## Summary of Items Discussed in 1/2020 APSEC Discussion Forum on 10 January 2020

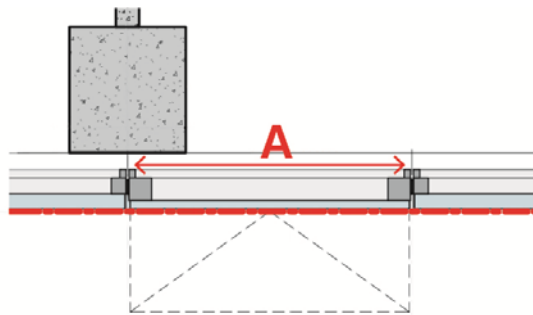
<p>15.</p>	<p><b><u>Determination of Openable Window Area</u></b></p> <p>Further to item 23 of ADF 5/2019, we would like to further enquire when 600mm clear opening could be provided at the top of sash of the openable window as per the below diagram, its openable window area is to be calculated based on the elevation area of such window:</p>	<p>BD advised the 600mm clear opening should be provided at the lowest point of the spandrel and the area obstructed by the protective barrier should be disregarded. BD also confirmed the window opening obstructed by the column should be disregarded.</p>

When the openable window sash is near to the structural column as per the below diagram, will BD accept Dimension A for calculation of the openable window area?
